# Access Compliance Report

## Public Rights-of-Way

### (Curb Ramps)

Intersection ID: 10037290	Main Street: SARDIS_RD_NORTH	Cross Street: N/A	Location: NW
ADA ID: 4B4B424105DC	Ramp Type: Directional1	Initial Pass/Fail: Fail	Overall Compliance: No
		Severity Score: 25

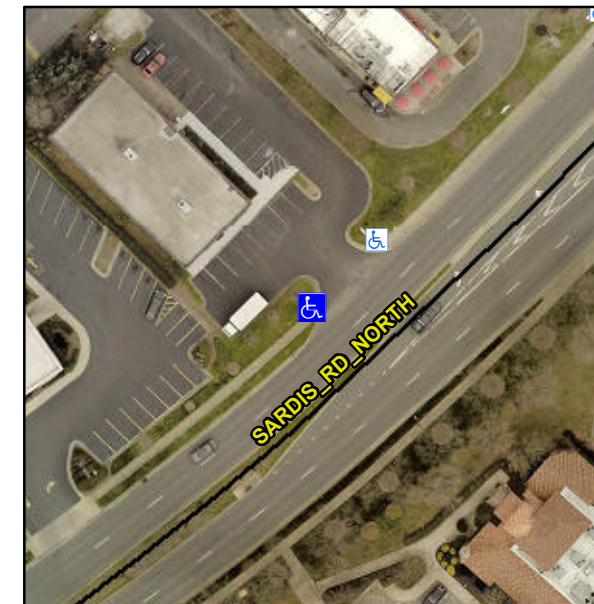
**R304.5.3**

Compliance	Description	Data	Compliance	Description	Data
N/A	Ramp Length (in)	38.0	N/A	Grade Break?	N/A
Yes	Ramp Width (in)	60.0	N/A	Grade Break Slope (%)	0.0
Yes	Ramp Slope (%)	6.8	N/A	Grade Break XSlope (%)	0.0
No	Ramp XSlope (%)	9.4			
N/A	Flare Type LT	N/A	N/A	Flare Type RT	N/A
N/A	Flare Slope LT (%)	N/A	N/A	Flare Slope RT (%)	0.0
N/A	Flare Traversable LT?	N/A	N/A	Flare Traversable RT?	N/A
N/A	Landing Length (in)	0.0	N/A	DWS Provided?	N/A
N/A	Landing Width (in)	0.0	N/A	DWS Contrast?	N/A
N/A	Landing Slope (%)	0.0	N/A	DWS Length (in)	N/A
N/A	Landing X Slope (%)	0.0	N/A	DWS Full Width?	N/A
N/A	Landing Curb? (Y/N)	N/A	N/A	DWS Offset LT (in)	N/A
N/A	Shared Landing?	N/A	N/A	DWS Offset RT (in)	N/A
N/A	Gutter Ponding?	0.0	N/A	Gutter Slope (%)	N/A
N/A	Gutter Lip Ht (in)	0.0	N/A	Gutter X Slope (%)	N/A
N/A	Painted X Walk1?	No		Road Slope (%)	2.2
	X Walk 1 Direction	To NE		Road X Slope (%)	2.5
	X Walk 1 Width (in)	N/A		Clear Space?	N/A

**Remove & Replace Entire Ramp.**
